project **Stanwell New Projects Office**
Switchyard Road,
Stanwell, QLD, 4702

title **Section Details - Facade - Entries**

title Plan Details - Facade

1.2.4 DOCUMENT REVIEW The reviewer shall review the documents submitted by the contractor to ensure that they are complete and accurate. The reviewer shall also ensure that the documents are in accordance with the contract requirements. The reviewer shall provide a written report of the review to the contractor within the specified time frame.	
A Reviewed by Contractor	B Reviewed by Consultant
C Reviewed by Employer	D Reviewed by Architect
Normal Kesejahteraan Date: 17/12/2025	
 Inhabiti Inhabiti Australia Pty Ltd

title **Section Details - Roof**

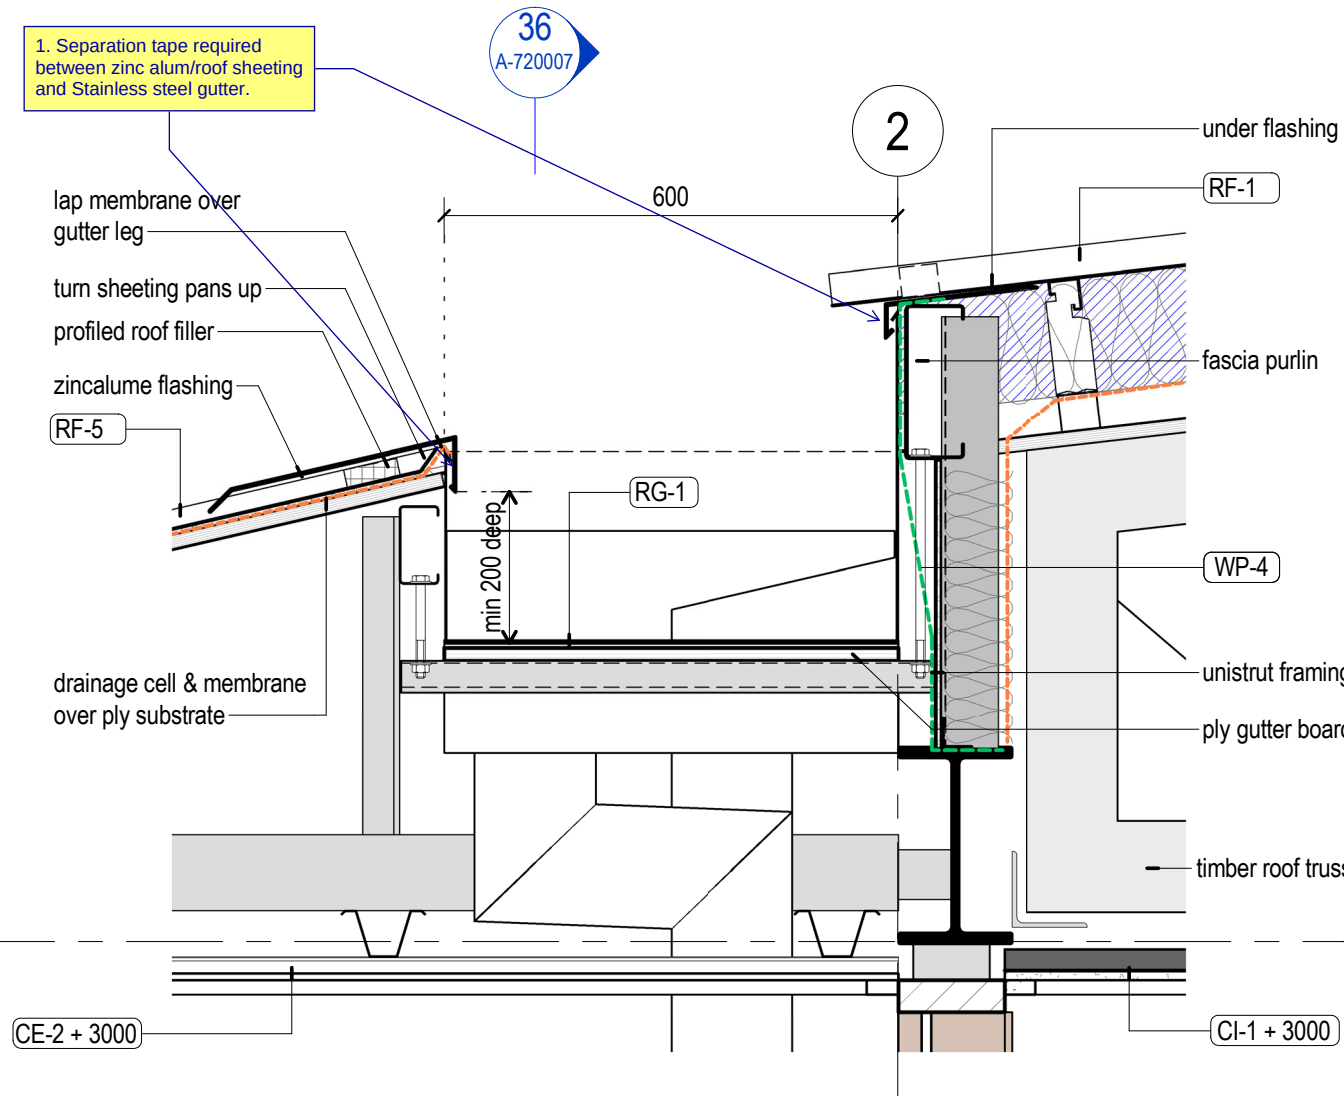
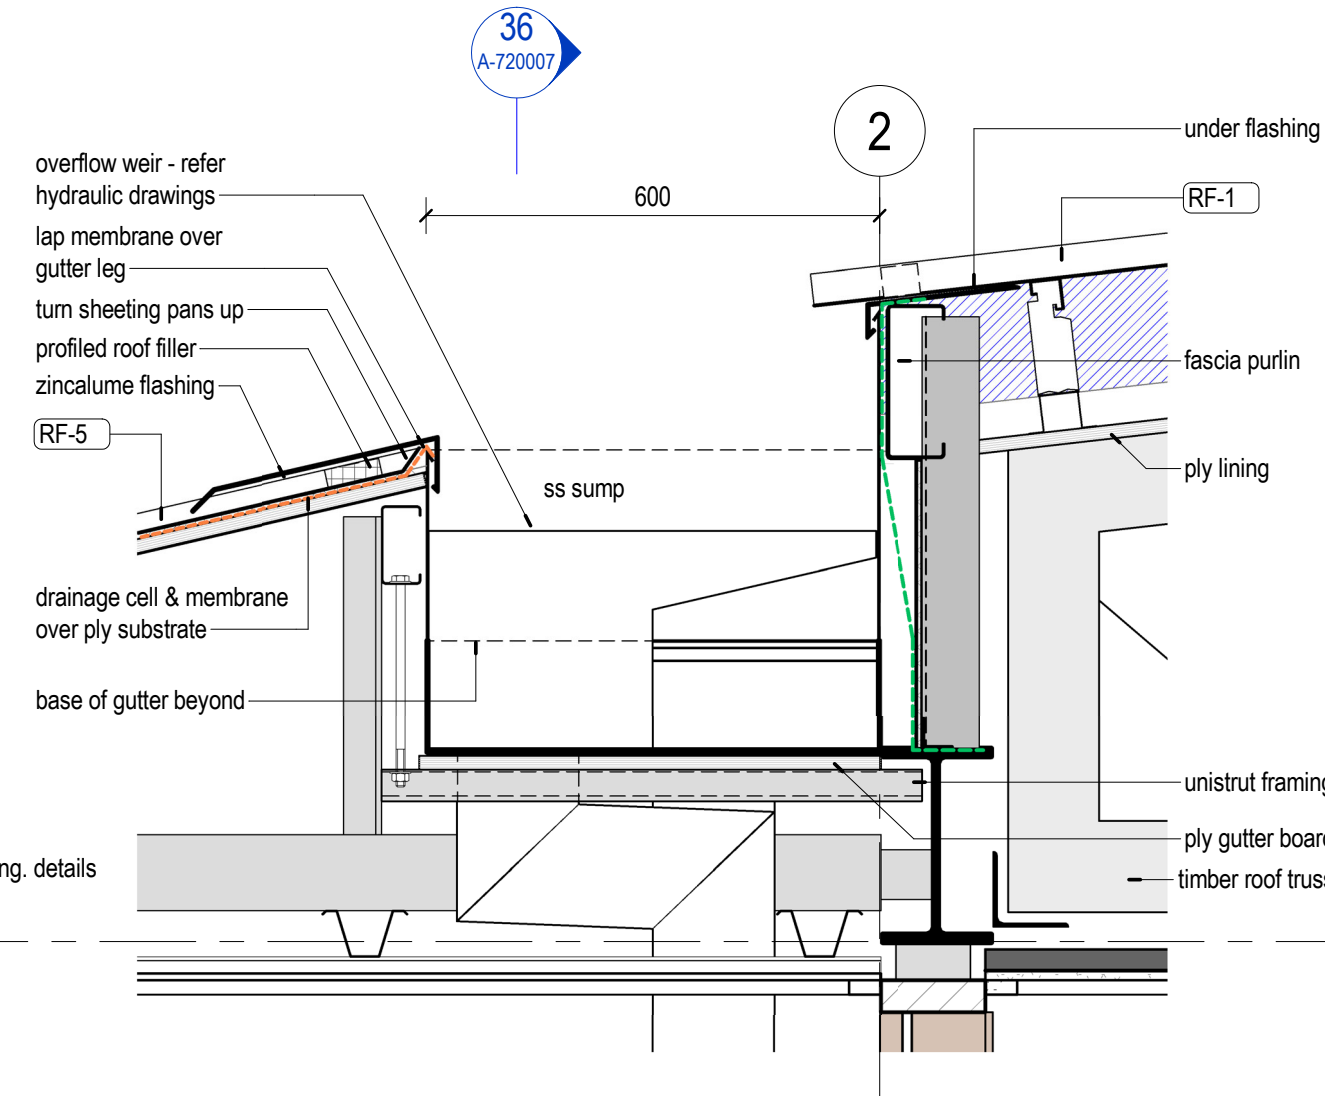
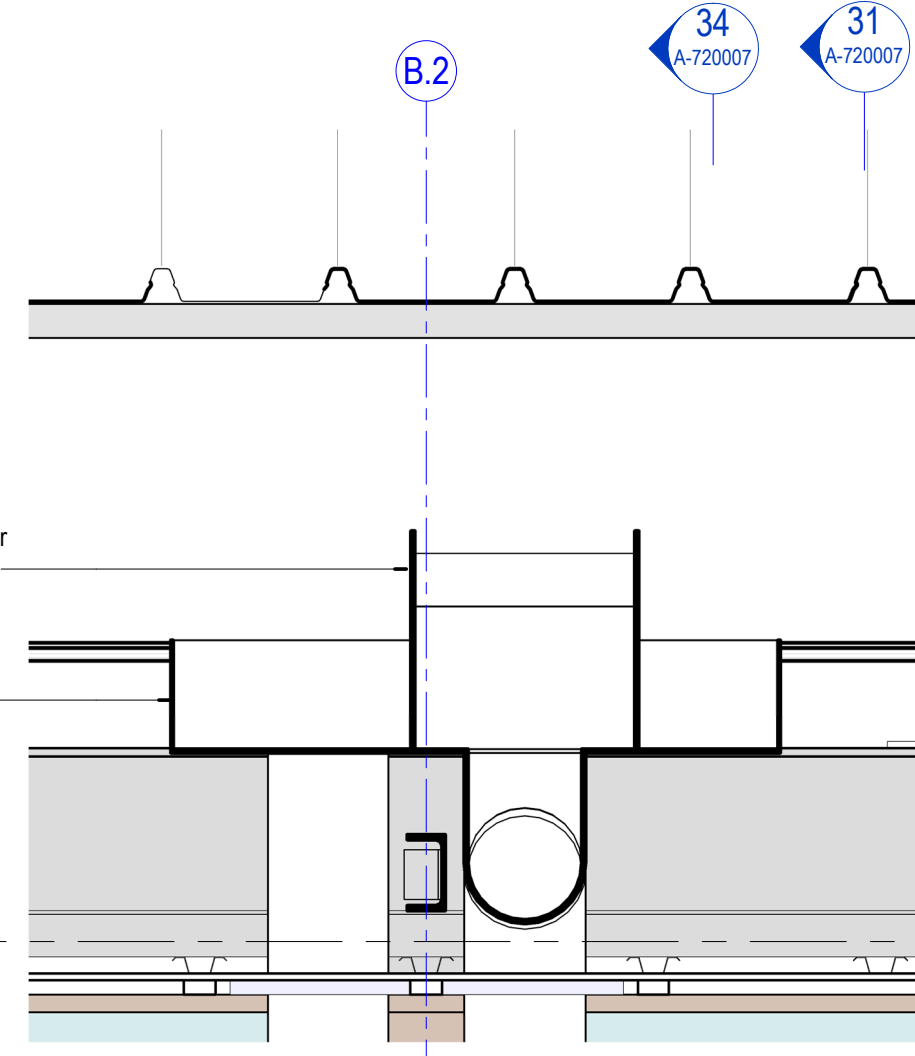
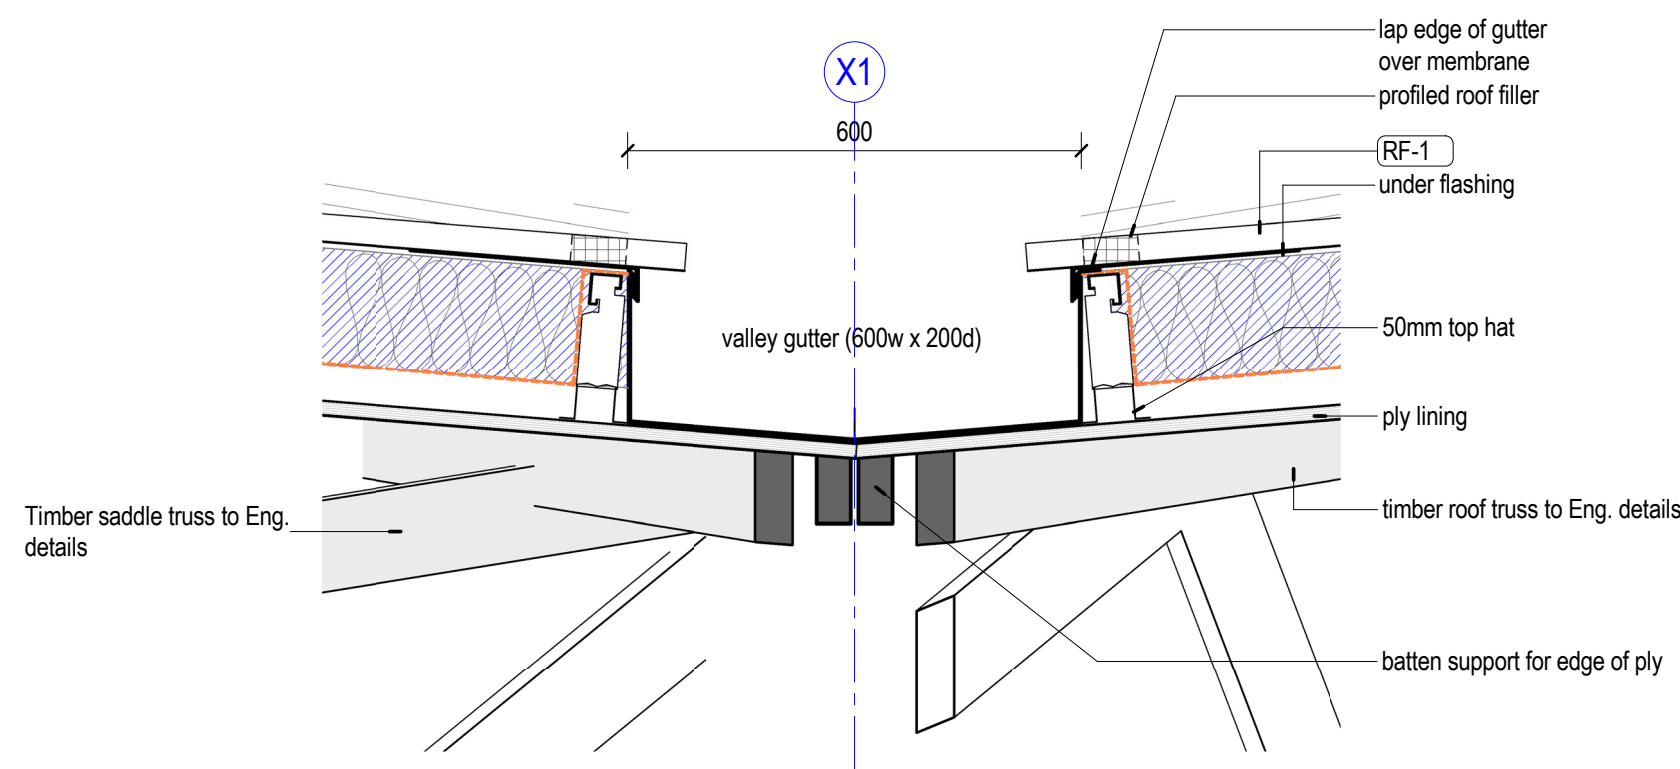
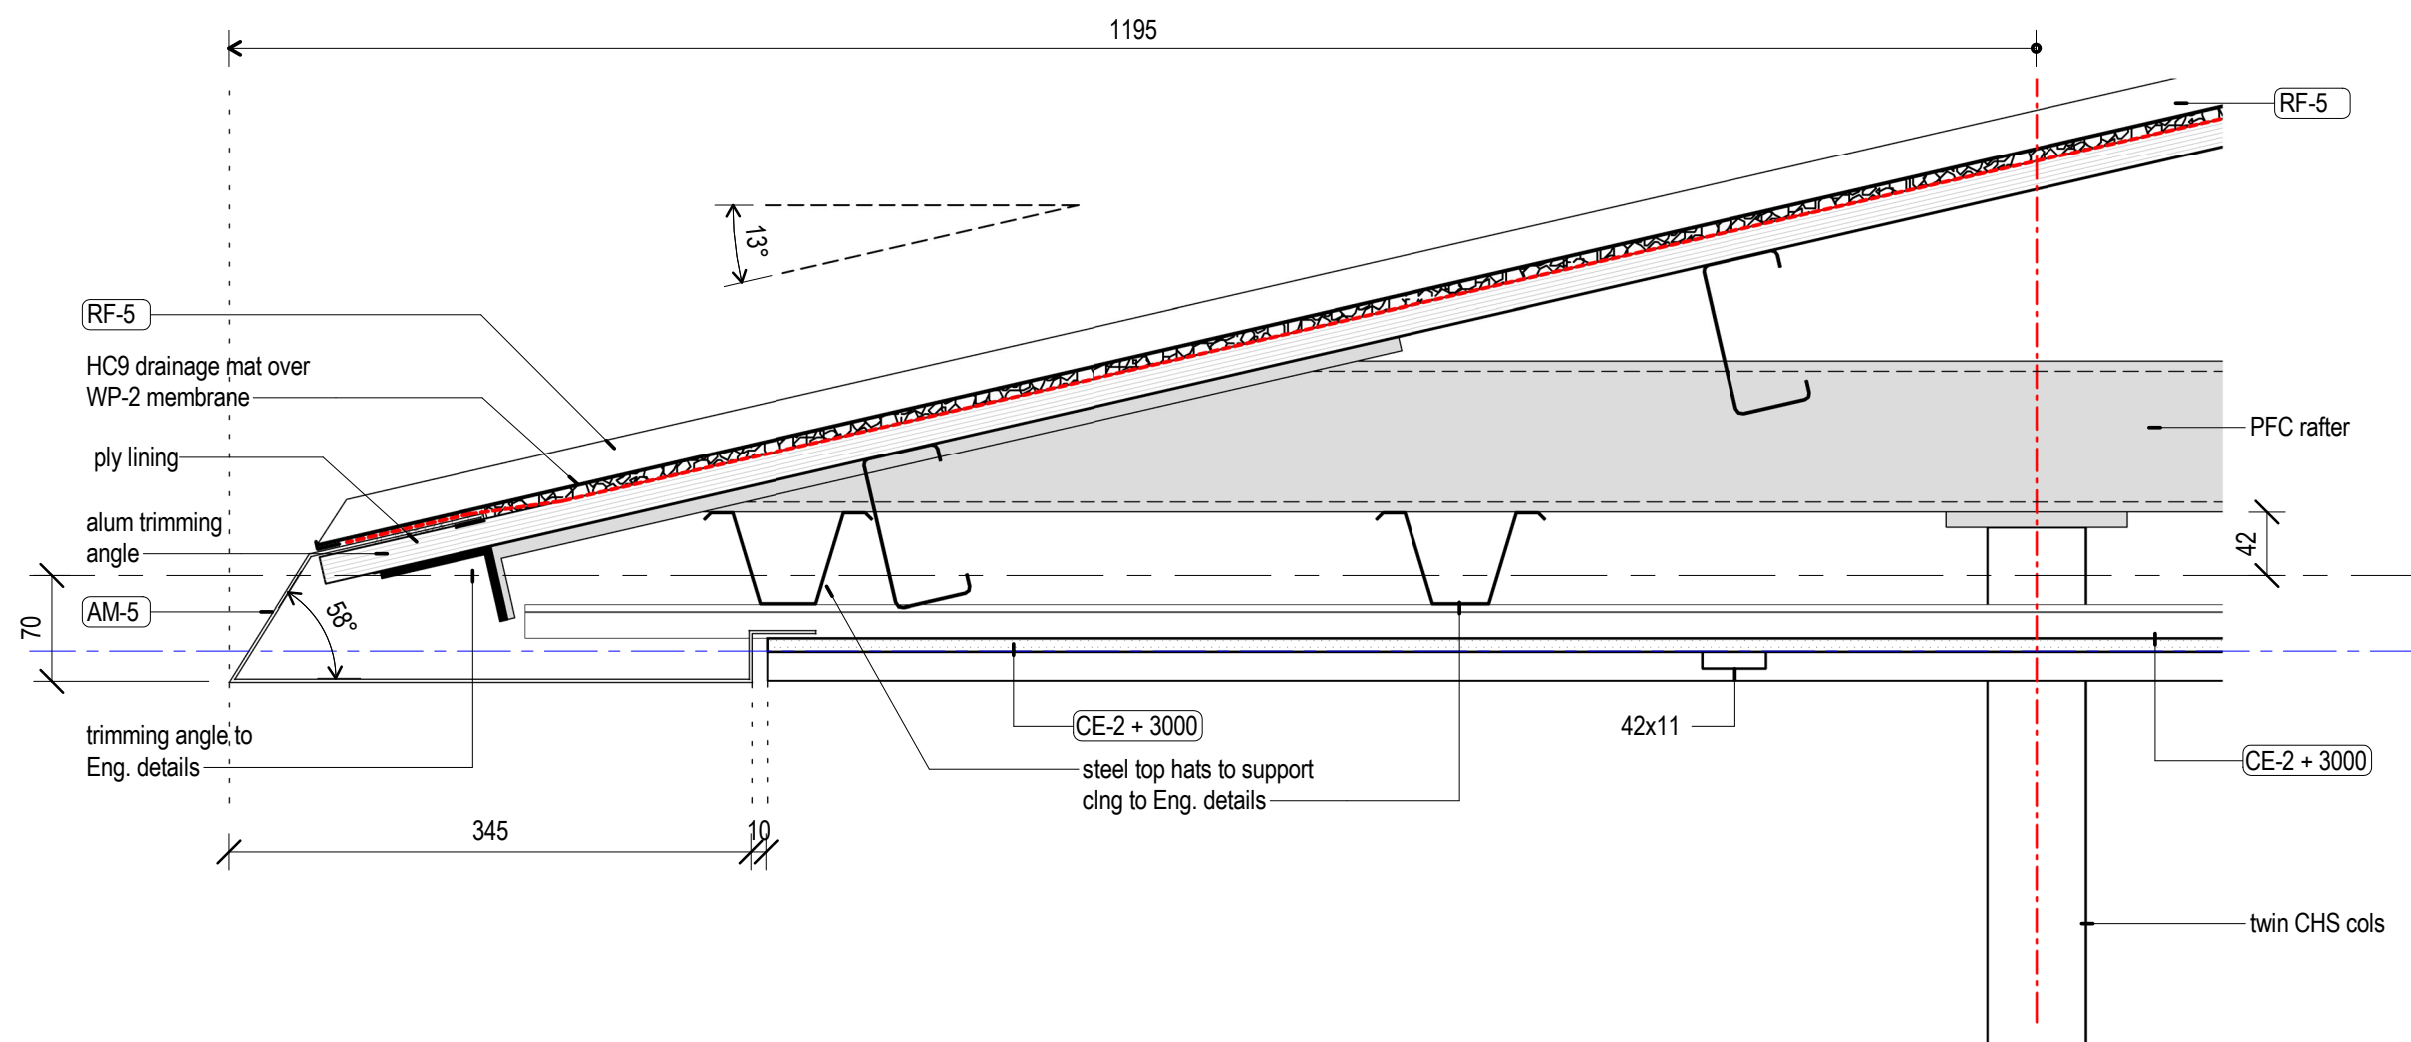
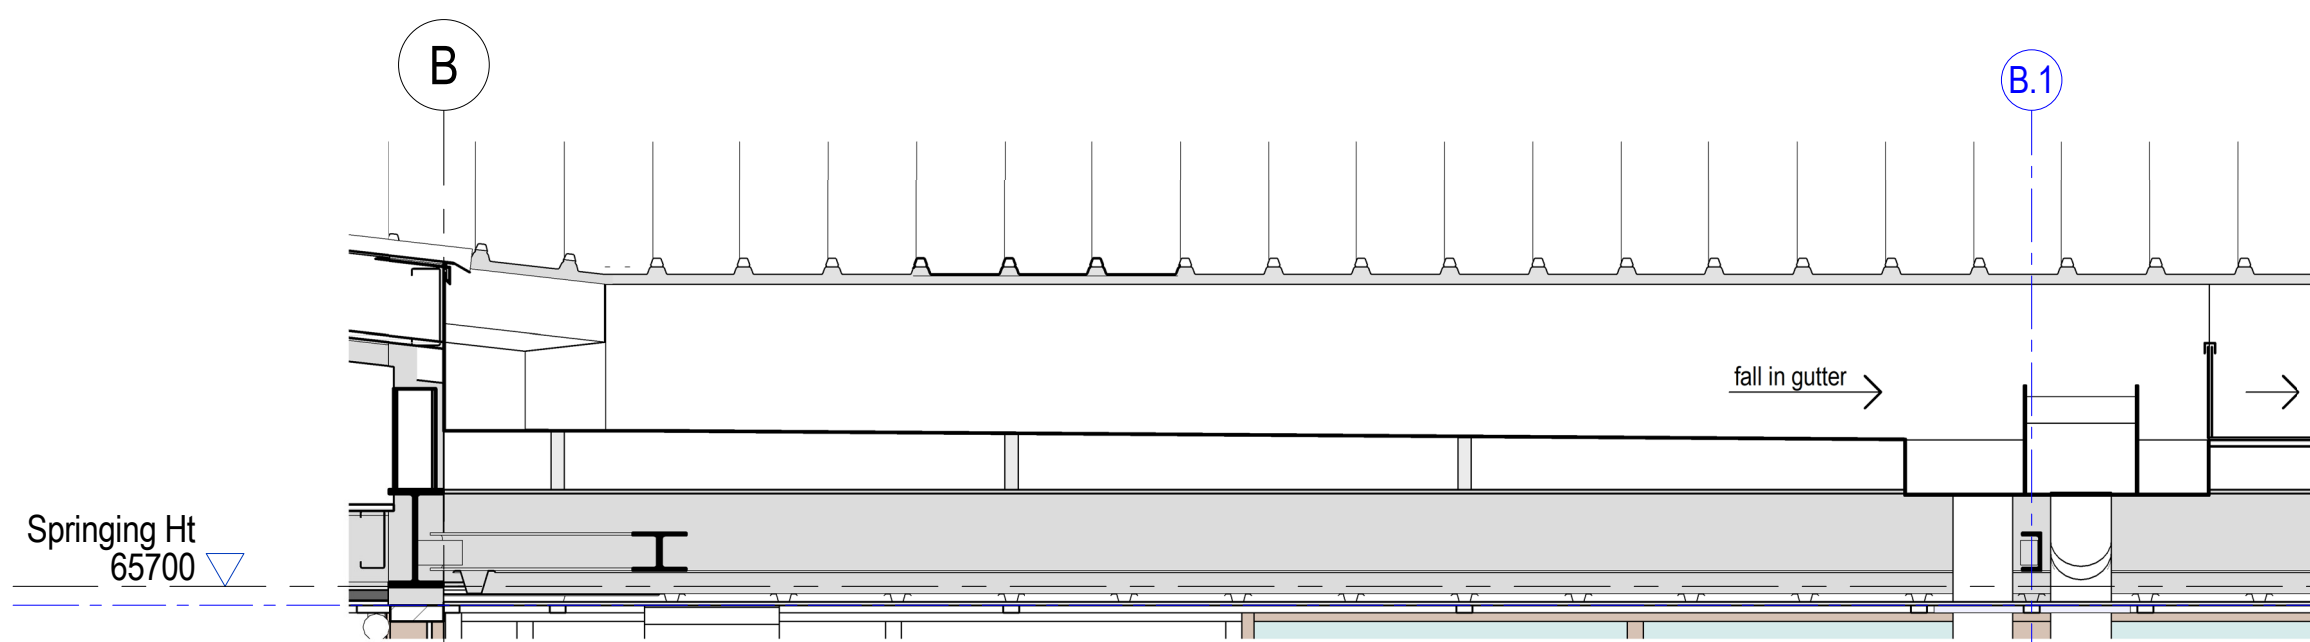
Notes:
1. All comments are applicable to similar details.
2. Gutter design by the hydraulic engineer.
3. Roofing design, including all roof flashings, to comply with AS 1562.1 and HB 39.
Roofing contractor to confirm compliance of design and installation via Form 12.
